Development Application: 50-58 Sir John Young Crescent, Woolloomooloo - D/2026/38

File Number: D/2026/38

Proposal Summary: Development consent is sought for alterations to, and the use of, the existing rooftop as an outdoor communal space for the existing backpackers' accommodation known as the Pacific House Hostel.

Summary Recommendation: This proposal is recommended for refusal.

Figure 13: Proposed plan - roof terrace

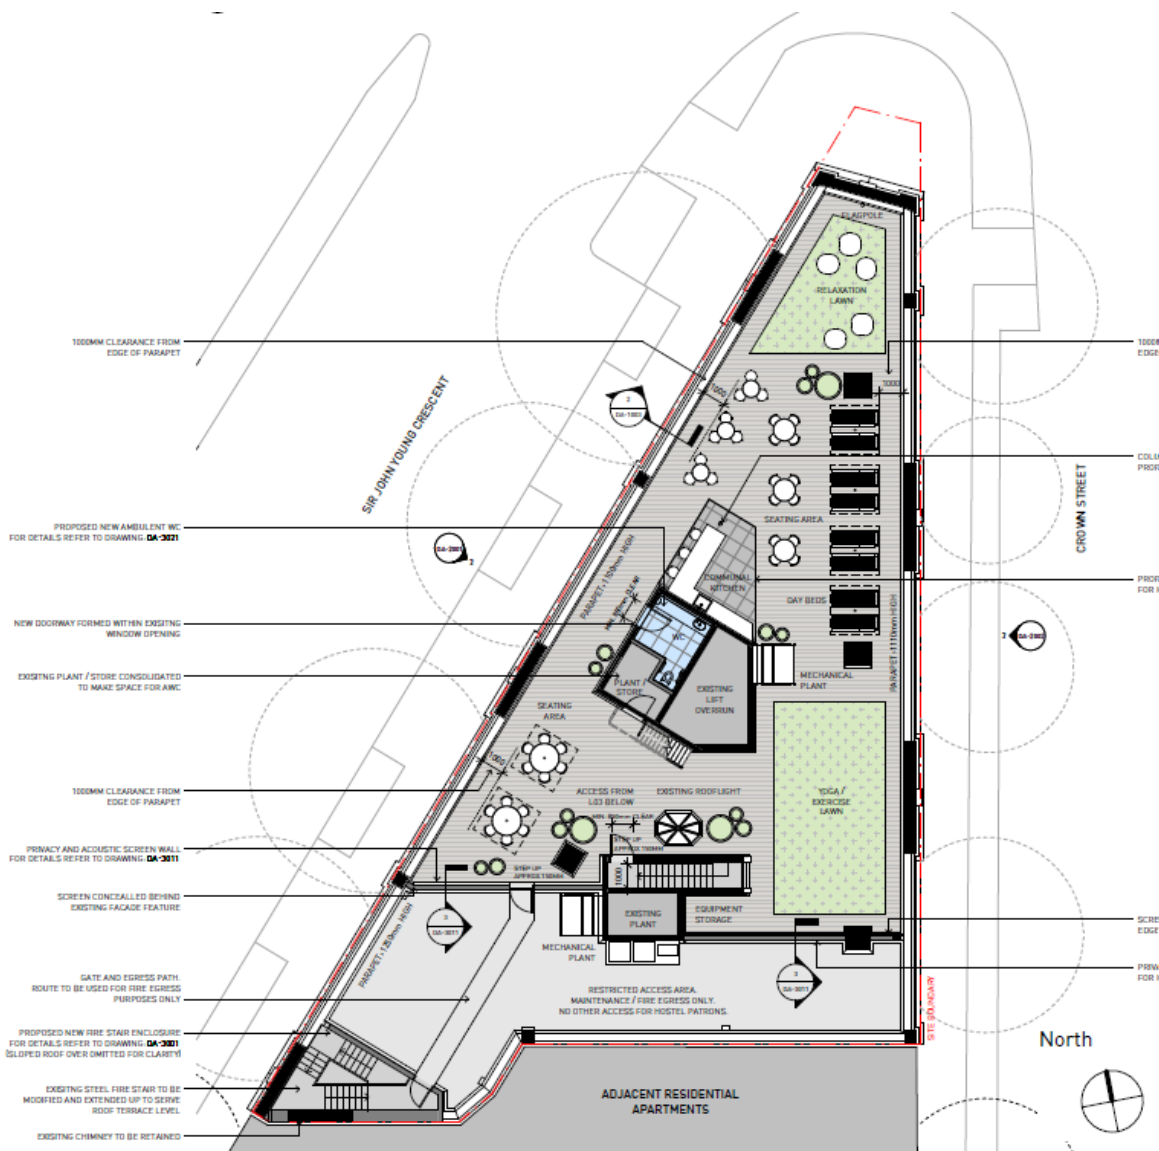
40. Applying the DCP requirement of 0.75 sqm per person, a total of 168 sqm of communal recreational area is required for 224 persons, with a maximum allowable outdoor area of 33.6 sqm (20%). The proposal includes a total rooftop area of 438 sqm, comprising 313 sqm of usable space and 125 sqm of restricted area.

- 50. Section 3.13 of the Sydney DCP 2012 requires development to provide a safe environment and to minimise opportunities for criminal and anti-social behaviour. The proposal includes a large area identified on the plans as “restricted access area” toward the southern portion of the rooftop, which raises crime prevention through environmental design (CPTED) concerns.

- 51. In practice, this area may not be restricted, as the fire egress door serving the space must remain unlocked and accessible to occupants using the rooftop. While the drawings indicate a defined path between the acoustic wall and the fire stair, there are no physical, visual, or operational measures to prevent residents from entering the broader restricted area. This area is largely concealed behind the acoustic wall, is not capable of passive surveillance from the main rooftop space, and may facilitate anti-social or noisy behaviour with potential impacts on adjoining properties. Although the plans annotate the area as “restricted access area,” the design does not incorporate any effective mechanisms to enforce this restriction. Consequently, the proposal does not adequately address the objectives of Provision (3) of Section 3.13.1 of the Sydney DCP relating to crime prevention through environmental design.

Figure 18: Proposed plan - acoustic screen wall

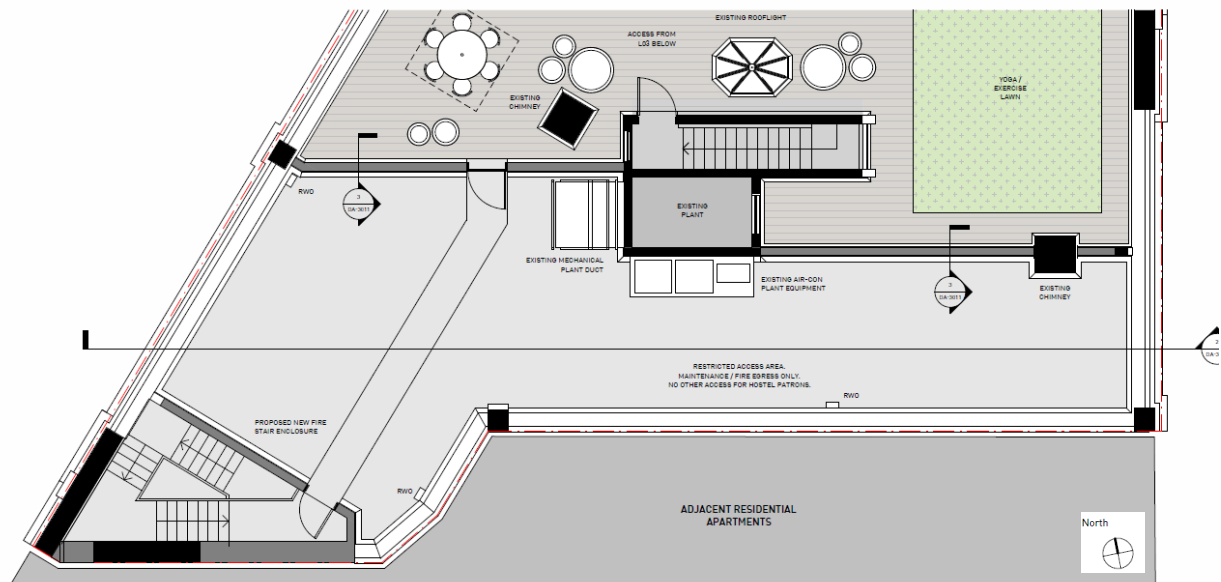
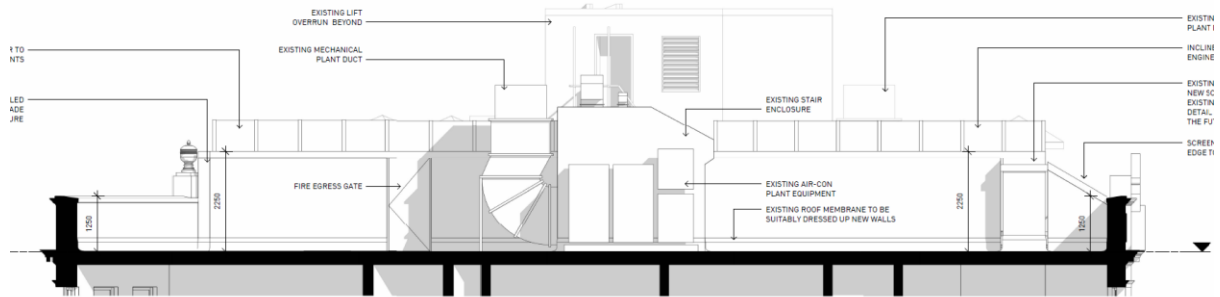
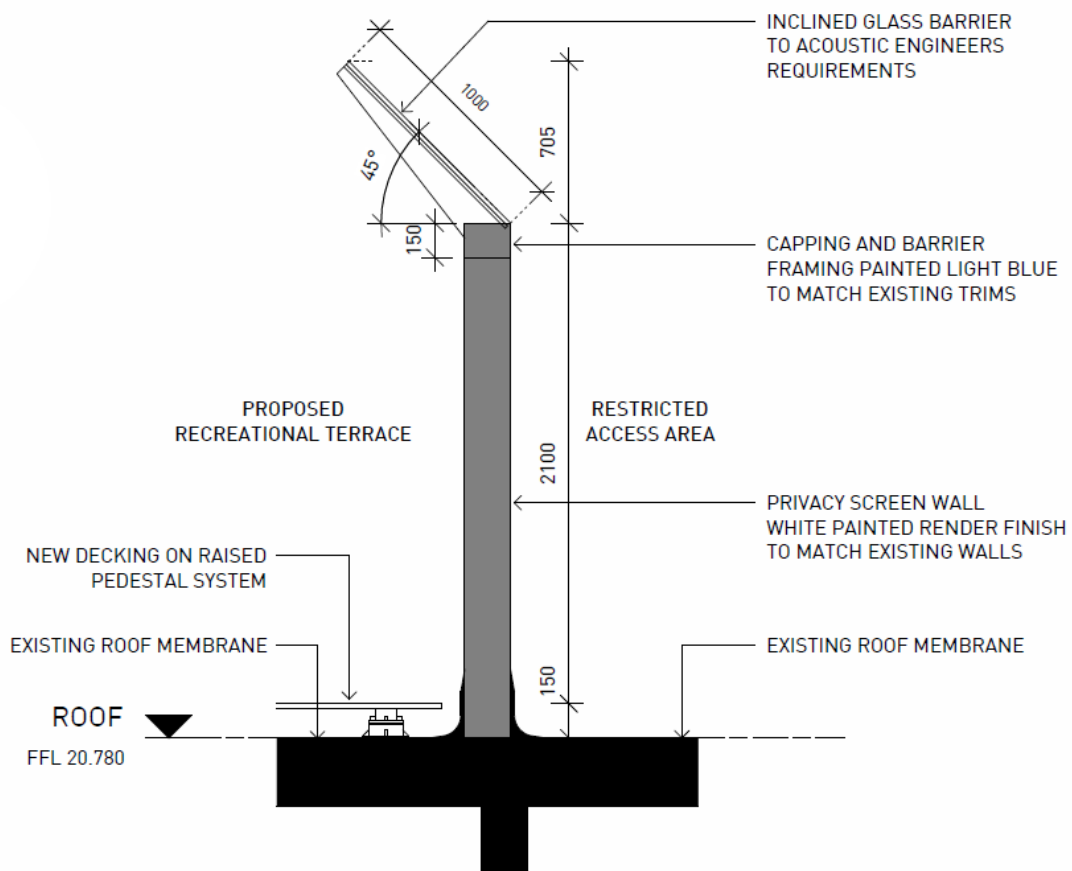
29. The proposal is accompanied by an acoustic assessment dated 18 December 2025, together with an acoustic response to submissions prepared by Pulse White Noise Acoustics.
30. The acoustic report includes a proposed acoustic screen wall (refer Figure 23 above). The proposed interface of the acoustic screen to the western parapet and the decorative urn is not supported on heritage and design excellence grounds. Any amendment to the acoustic screen to address heritage and design concerns would alter the form, height, or extent of the screen and, as a result, may invalidate or affect the outcomes and conclusions of the submitted acoustic assessment. Accordingly, the acoustic impacts of the proposal cannot be adequately resolved or supported based on the current application.

Response: The proposed acoustic screen provides a separation distance of approximately 9.5 m to the west and 4.2 m to the east between the usable rooftop area and the southern site boundary. This area is identified as a restricted access area. These separation distances are generally considered acceptable, and it is noted that the north-facing balconies of the adjoining southern apartments also borrowing a degree of visual amenity from the subject site. However, as discussed elsewhere in this report, the effectiveness of the proposed restricted access area is uncertain. The fire egress door serving the rooftop must remain unlocked and freely accessible, which undermines the ability to genuinely restrict access to this area. This raises ongoing concerns regarding amenity and safety impacts.

Figure 22: Proposed with 18m height LEP envelope

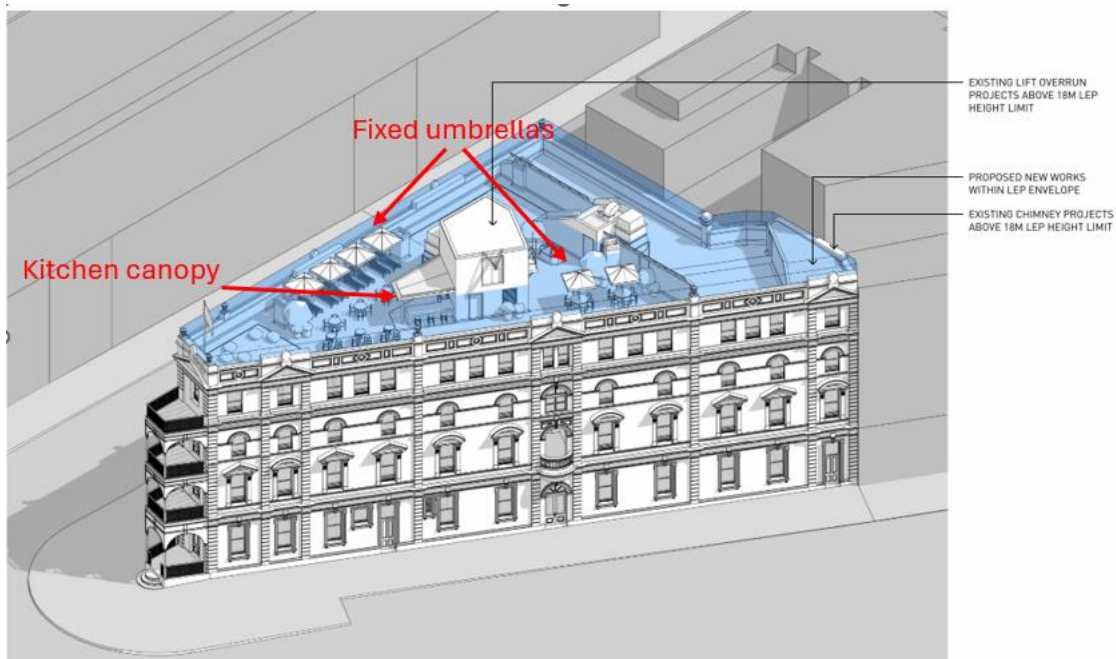
20. However, as demonstrated in Figure 22 below, both the proposed fixed umbrellas and the proposed canopy above the kitchen area exceed the 18-metre height limit under the Sydney LEP 2012. These structures are not excluded from the LEP definition of 'building height' and therefore must be included in the height calculation. The fixed umbrellas reach a maximum height of 18.8 metres (a 4.4% exceedance), while the canopy reaches 18.5 metres (a 2.7% exceedance).

24. Accordingly, the proposed non-compliance with the height development standard cannot be supported, as the applicant has not provided information to adequately address the matters required to be addressed by Clause 4.6(3) of the Sydney Local Environmental Plan 2012.

Figure 23: Section of proposed acoustic screen wall

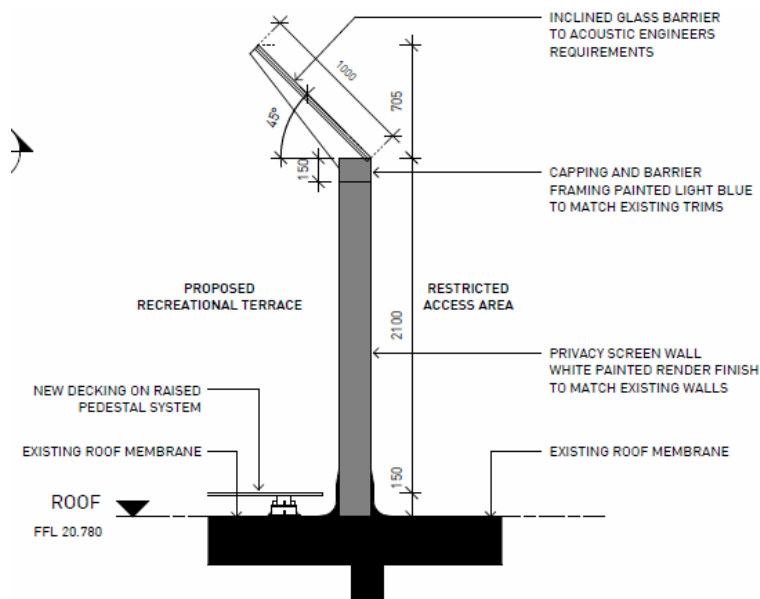
26. The proposal includes the construction of a 2.1m-high rendered acoustic wall along the southern side of the usable rooftop area, with an additional 1m glazing returning at a 45-degree angle (refer to Figure 23). The parapet ornamentation, including the prominent urn, is a significant architectural feature of the building and must be conserved. The proposed interface between the acoustic wall and the western parapet and decorative urn is not supported, as it would result in an unacceptable impact on the significance of the heritage item (refer to Figure 24).

27. In addition, the proposed rooftop fixed umbrellas and the poorly resolved acoustic wall would be visible from Sir John Young Crescent and The Domain. These elements do not complement the heritage item due to their height, scale, and prominent location, and would detract from the building's historic character and visual presentation.

Figure 25: Measurement locations and surrounding receivers

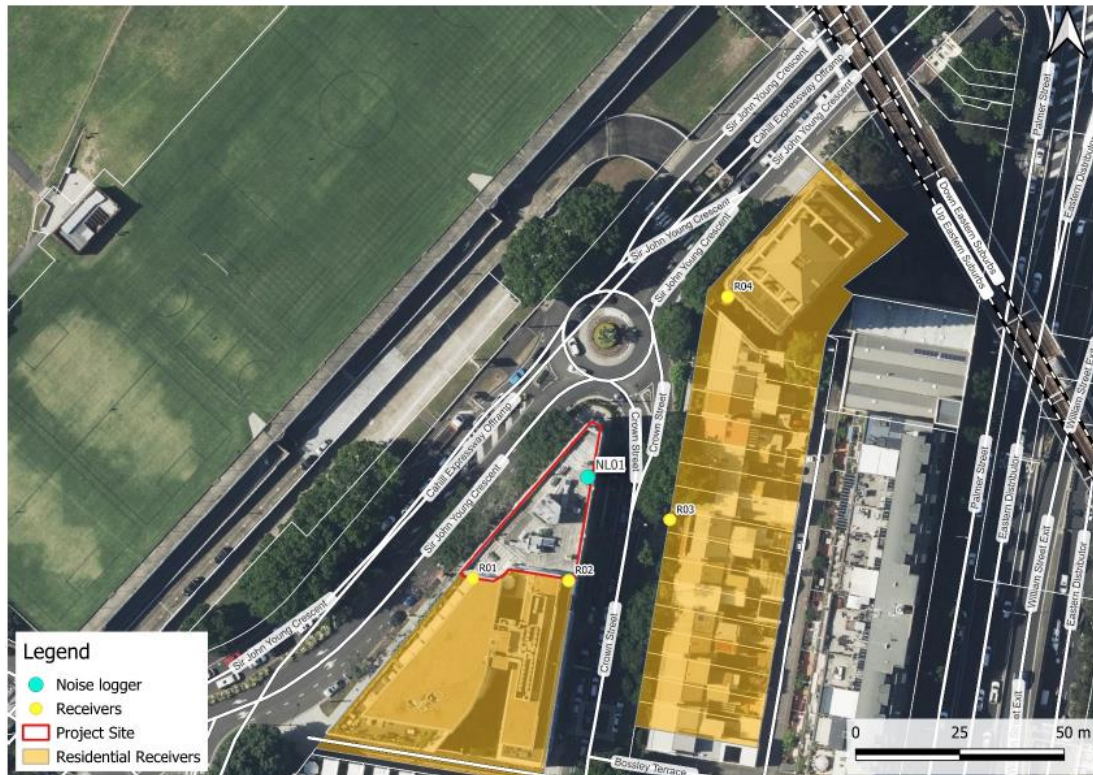
31. The acoustic assessment relies on previously completed noise logging undertaken by Renzo Tonin, as documented in the report 50–58 Sir John Young Crescent, Woolloomooloo – Use of Rooftop Terrace dated 6 December 2024 (which was submitted in the previously withdrawn application (D/2025/268)). However, the noise monitoring conducted by Renzo Tonin is not considered appropriate, as the noise logger is located on the north east side of the rooftop (refer to Figure 25).

34. The report has not provided a comparison of long-term monitoring data with attended measurements undertaken during the same or comparable time periods, nor has it included new long-term background monitoring at a more representative and quieter location.
